Technical Update

Product: ABL90 FLEX

Scope: Release of Software V2.8

Ref.: TU0092

1.1 Reportable range

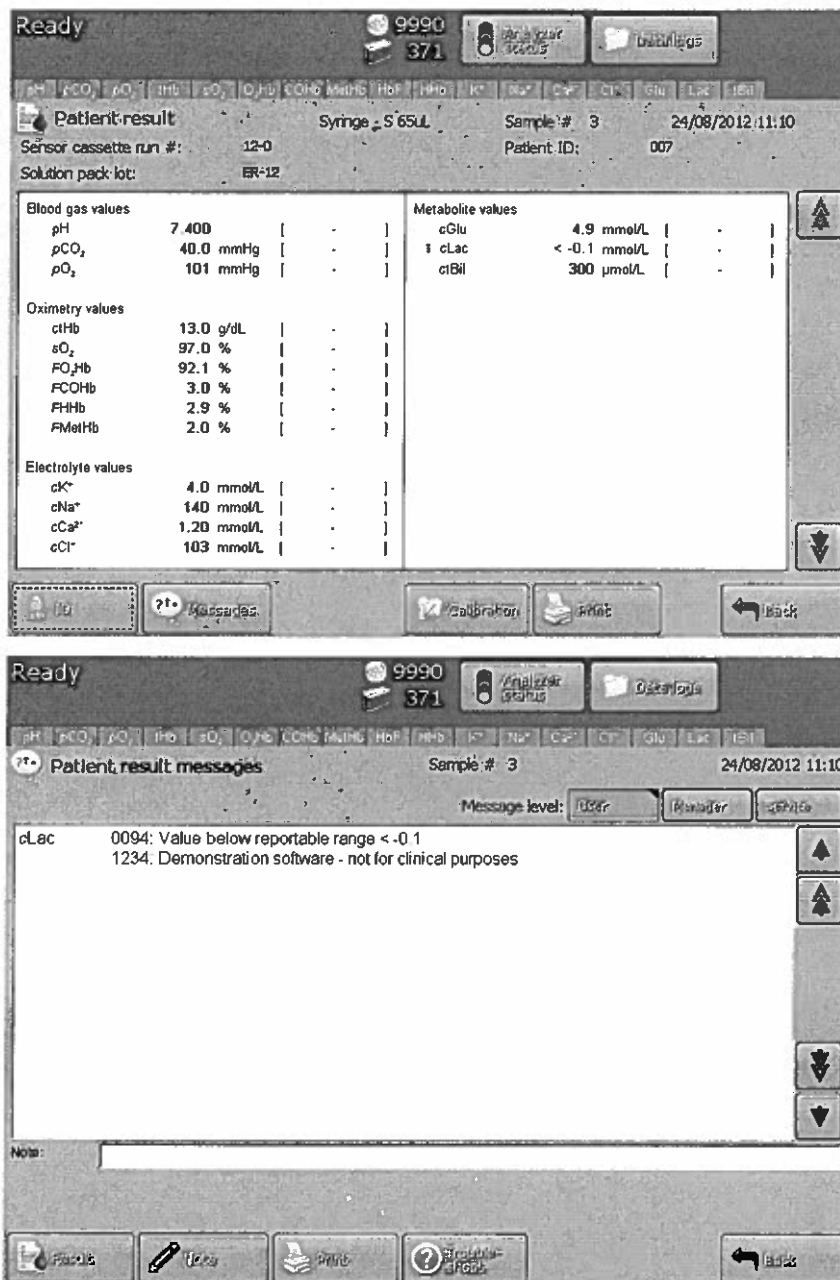
Radiometer has added the possibility of showing the exceeded reportable range instead of a blank result if the measured parameter is outside of the reportable range.

If so enabled, results below Reportable Ranges will be shown as '< x.xxx' and result above Reportable Ranges will be shown as '> x.xxx' where 'x.xxx' is the actually exceeded limit.

Furthermore error messages 0093 and 0094 will now have the range in the text:

The triple up or down arrow will still be tagged to the parameter

See example below where the measured Lactate is below the reportable range of -0.1 mmol/L.

1.4 tHb offset

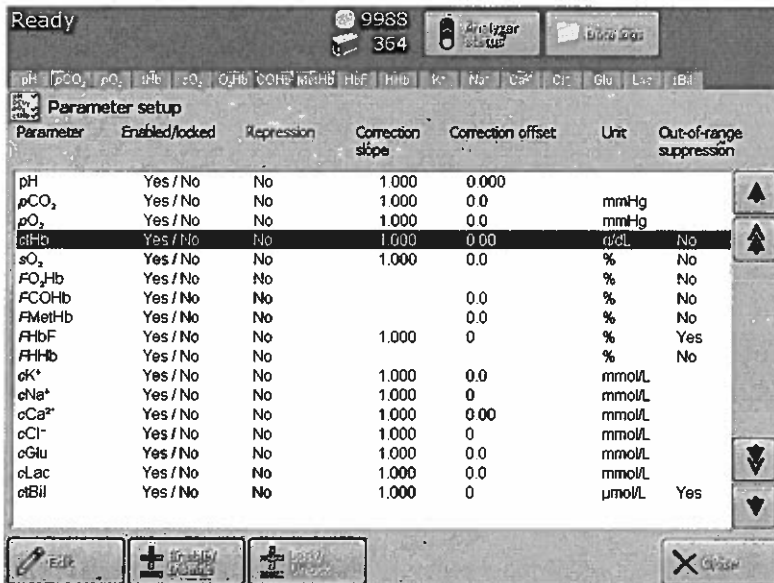
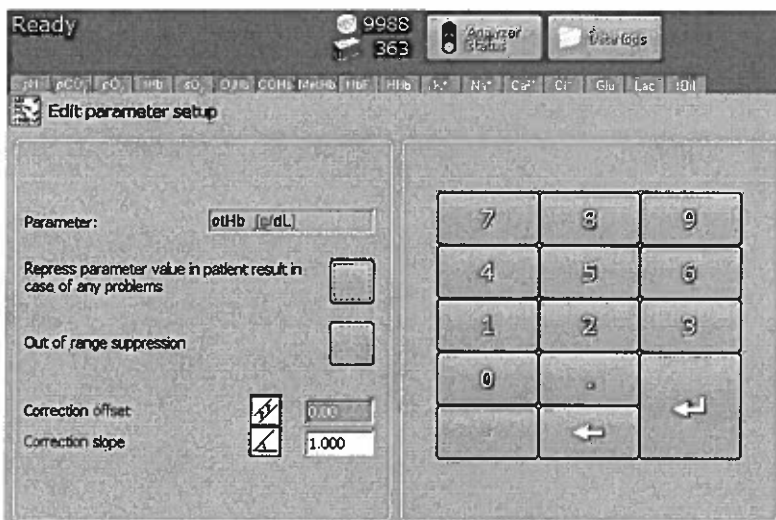
It is now possible to adjust both offset and slope for the tHb, previous versions only allowed correction of the slope. See example below.

Please note that how much the offset can be changed is limited to +/- 2 mmol/L.

1.5 User interface

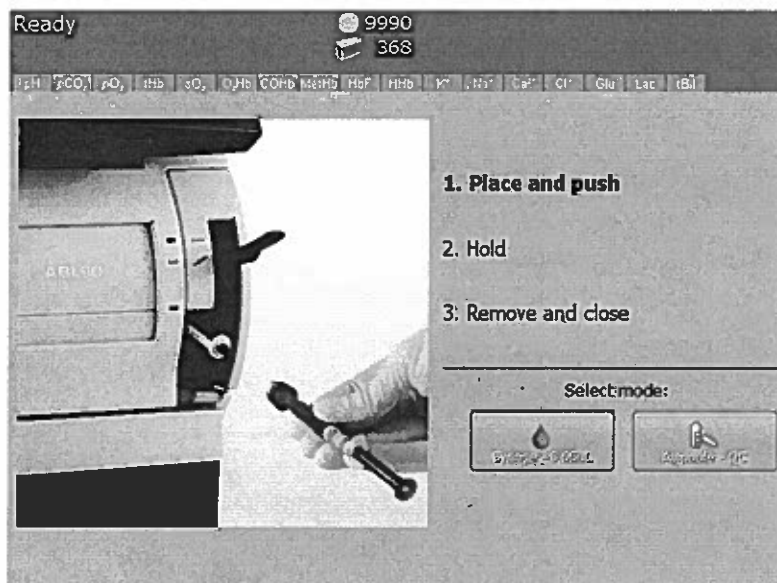
A general update of the user interface has been made. This means that most of the animated videos are now replaced with "live" videos.

The sample process has also been updated with a three step process and video, in order to better guide the operator through the sample aspiration process.
